COUNCIL ASSESSMENT REPORT

SOUTHERN REGIONAL PLANNING PANEL

PANEL REFERENCE & DA NUMBER	PPSSTH310 – DA0459/2023
PROPOSAL	Boat storage and maintenance facility, office and cafe
ADDRESS	Lot 1061 DP 1253523 5 Maritime Drive, Shell Cove Alternative address 15 Maritime Drive, Shell Cove
APPLICANT	Australand Corporation (NSW) Pty Ltd
OWNER	Shellharbour City Council
DA LODGEMENT DATE	3.11.2023
APPLICATION TYPE	Nominate Integrated Designated Development
REGIONALLY SIGNIFICANT CRITERIA	Section 2.19(1) and Clause 2 of Schedule 6 of State Environmental Planning Policy (Planning Systems) 2021 declares the proposal regionally significant development as the development has a capital investment value of over \$30 million.
CIV	\$32,323,622 (excluding GST)
CLAUSE 4.6 REQUESTS	None
LIST OF ALL RELEVANT PLANNING CONTROLS (S4.15(1)(A) OF EP&A ACT)	<ul style="list-style-type: none"> • State Environmental Planning Policy (Industry and Employment) 2021 • State Environmental Planning Policy (Planning Systems) 2021 • State Environmental Planning Policy (Resilience and Hazards) 2021 • State Environmental Planning Policy (Resources and Energy) 2021 • State Environmental Planning Policy (Transport and Infras

Figure 6 - Areas of height exceedance (shown in red)

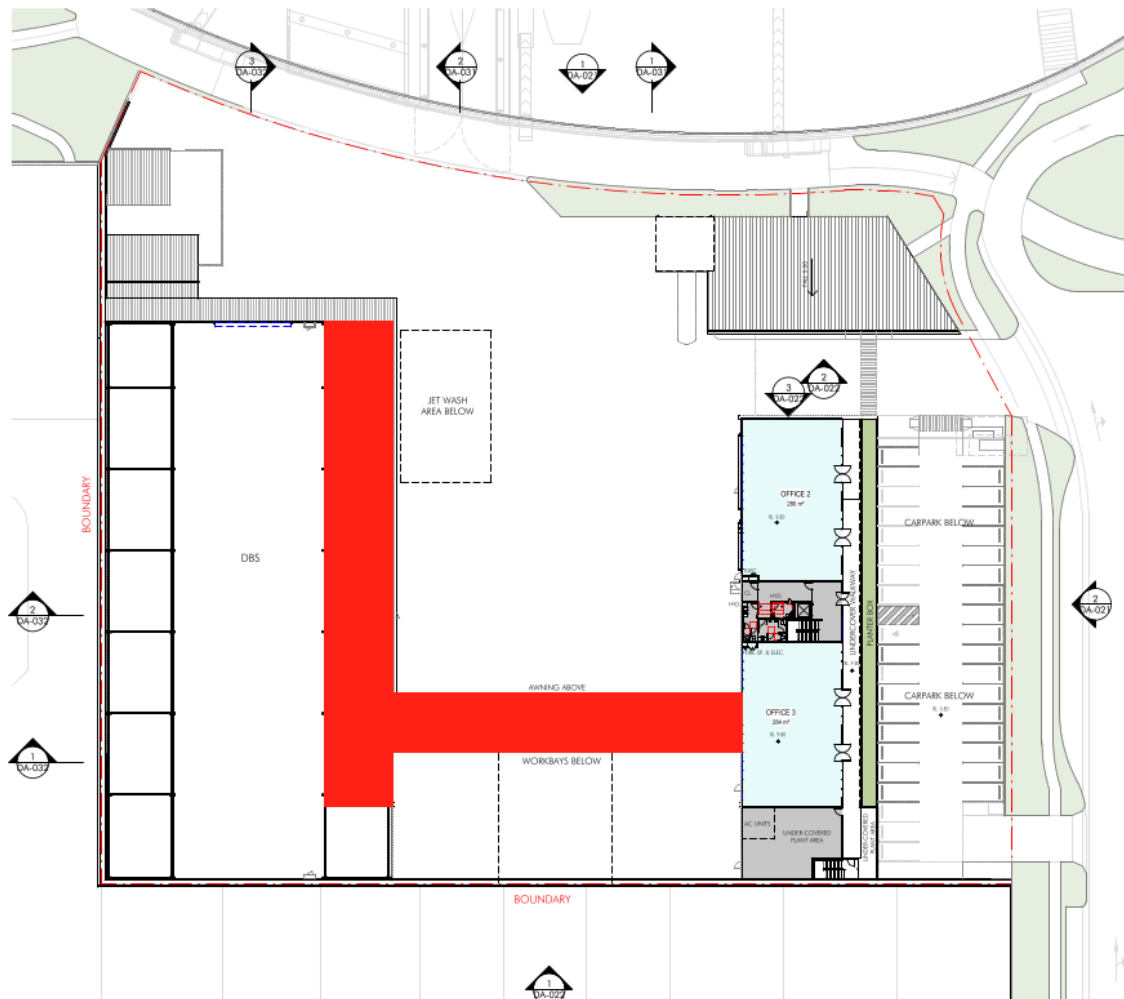
The proposed development will have a maximum height of 15.2 metres. The sections that will exceed the maximum height limit are within the central areas of the site as shown on figure 6 below in red. The applicant has provided a Visual Impact Assessment (VIA) in support of the development that the height breaches will be minor and imperceptible from key locations as identified in the VIA and from the surrounding public domain. Council concurs that the height

variation to the highest points of the will not be noticeable and does not raise objection to this minor breach nor considers that they are inconsistent with the concept approval.

It is noted that the southern setback requirement of 10 metres in height is an important element of the development due to the close proximity to the adjoining dwellings fronting Seaboard Way. The scale of the elevational plans does not suitably satisfy Council that the 10-metre height is maintained for the entire length of the 10 metres setback. A condition of consent is recommended to ensure the height of this section of the development does not exceed 10 metres.

- a. The maximum height of the development within 10 metres of the southern setback of the site is to not exceed 10 metres.**
- b. Suitable areas for pedestrians to wait whilst the pedestrian boardwalk is closed are to be identified and embellished accordingly with suitable seating and shade.*
- c. Signage plans detailing suitable wayfinding signs for the alternative pedestrian route.*
- d. Suitable waste storage areas within the footprint of the development for each unit.*

Figure 18 - External areas of BMF to be lit highlighted in yellow and blue

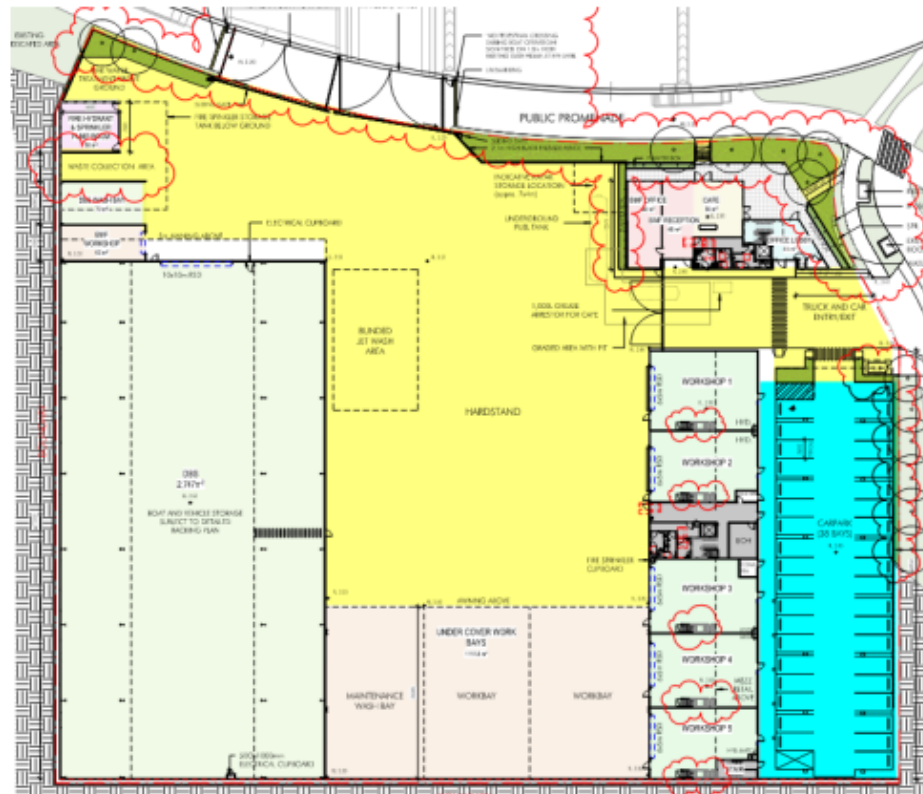
A light spill assessment has been submitted in support of the application and reviewed by Council assessment officers. The report identifies the external areas of the facility to be lot as shown in figure 18 below.

Figure 19 part elevation showing where car park adjoins residential boundary

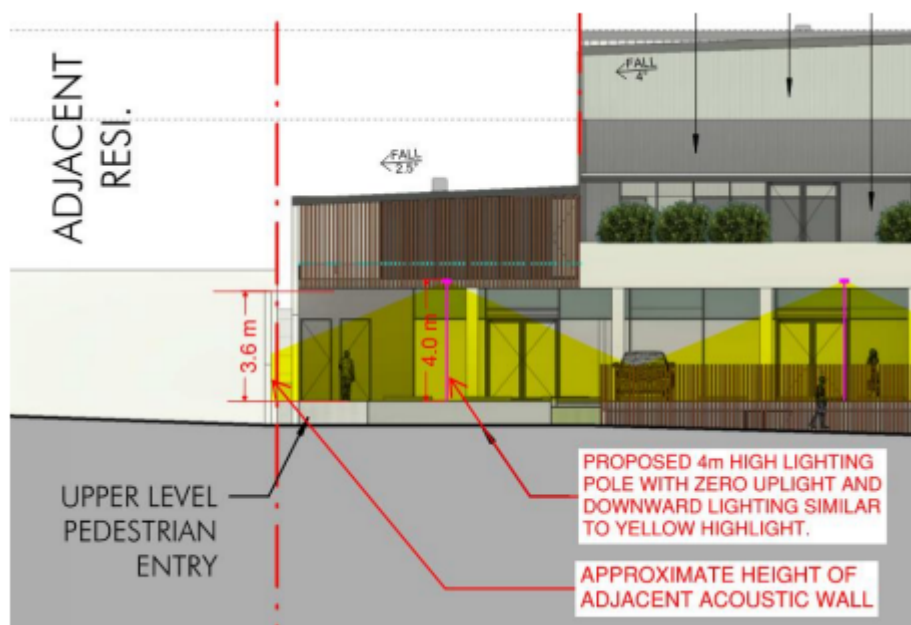
For the car park lighting the report identifies that lighting will not have an upward lighting component with a *cut-off below the horizon of 20-25 degrees that will inhibit lighting spill over the acoustic wall*. This is shown in figure 19 below.

Figure 20 - Hard standing external lighting

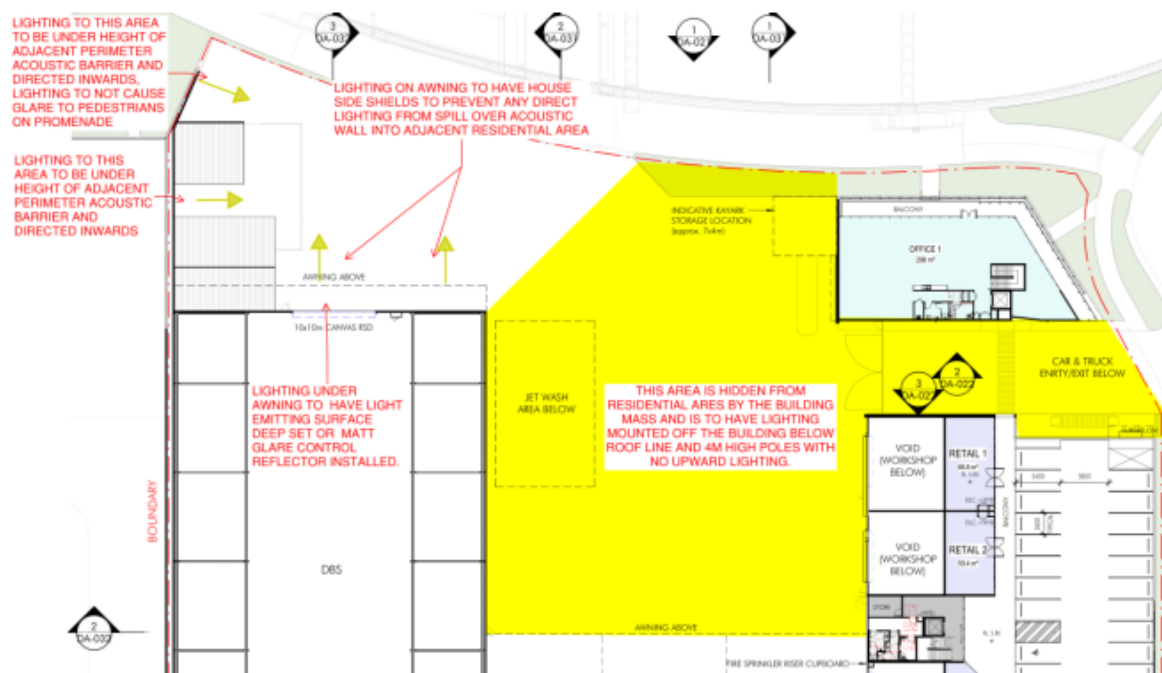
The hard standing area is to have lighting that does not include an upward lighting output and as specified in the report *be primarily directed away from the residential areas per yellow arrows*. Figure 20 below details this.

For all lighting the report concludes that compliance with Australian Standard 4282.1 – Control of the obtrusive effects of outdoor lighting can be achieved. A condition of consent has been recommended to ensure the detailed lighting schedule complies with the Light Spill Assessment
